Assessment of Dam Safety

Coal Combustion Surface Impoundments (Task 3)

FirstEnergy Generation
Corporation

Bruce Mansfield
Power Plant
Little Blue Run Dam
Shippingport, Pennsylvania

PROJECT NO.
20085.8000
DATE: 02/2010
FIGURE 7

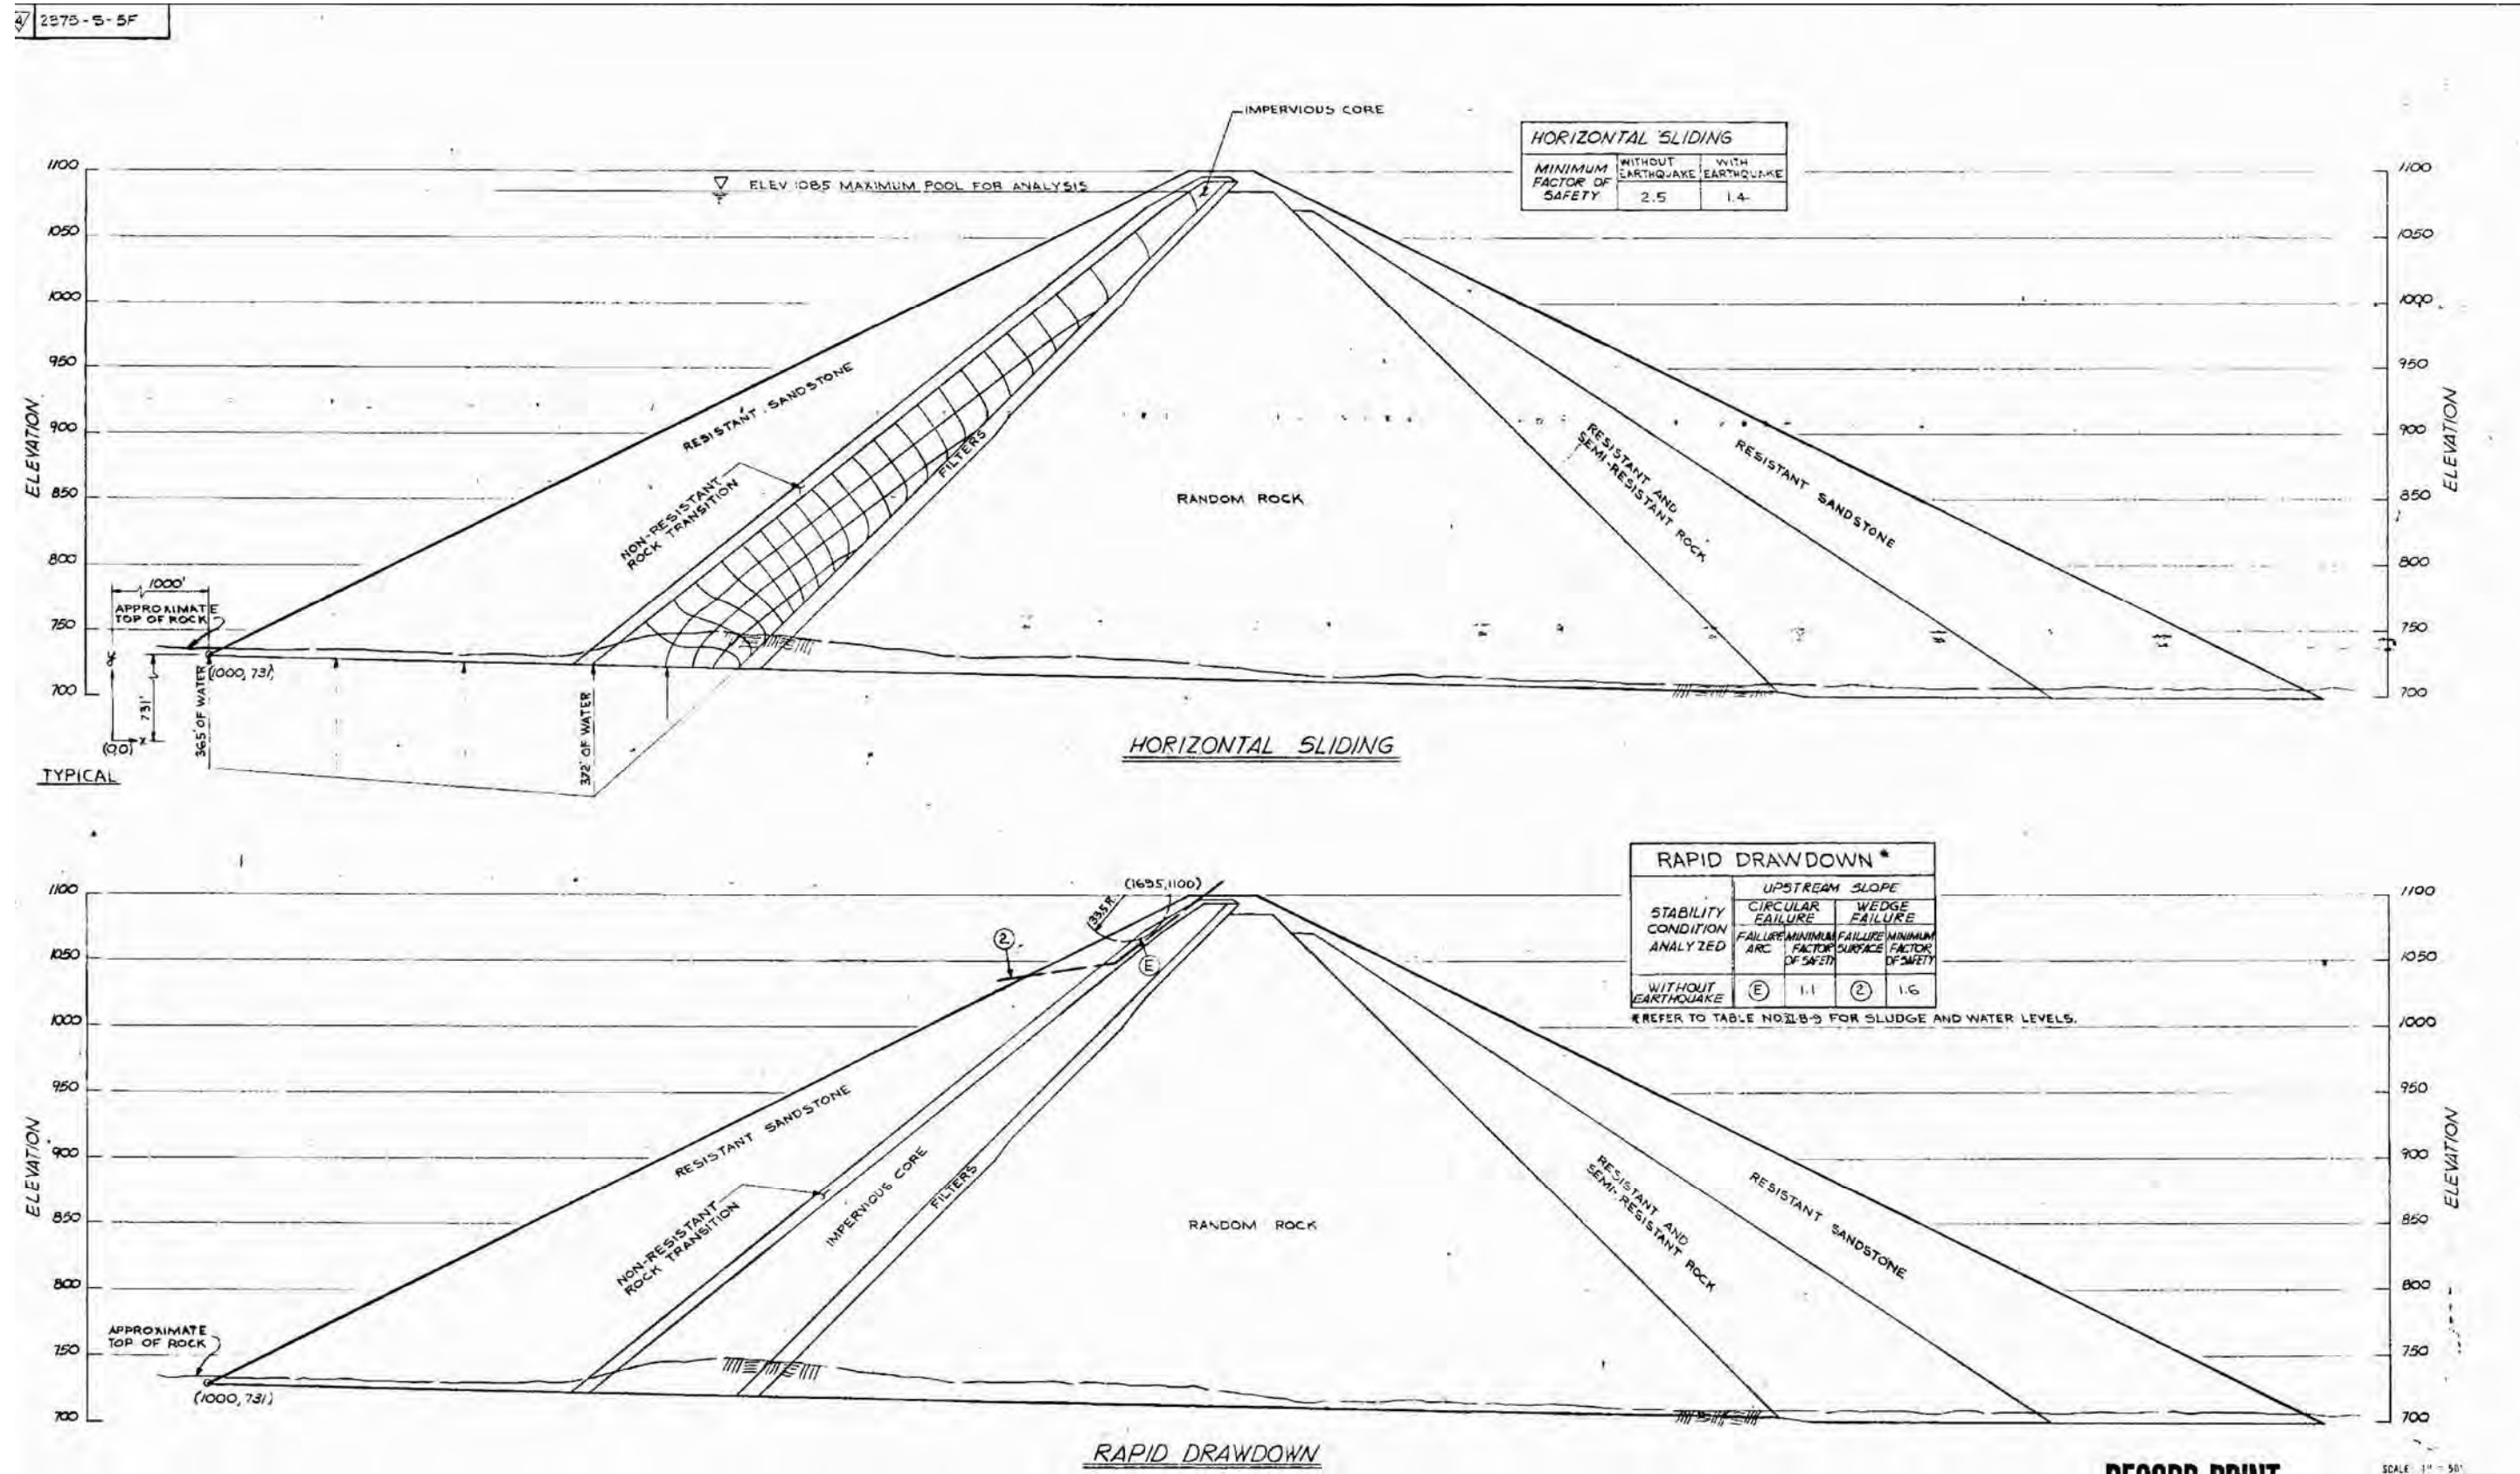
The 1977 As-Built Drawings for the Little Blue Run Dam show engineering analyses results for stability. Figure 6 and Figure 7 show the cross sections modeled and the corresponding results.
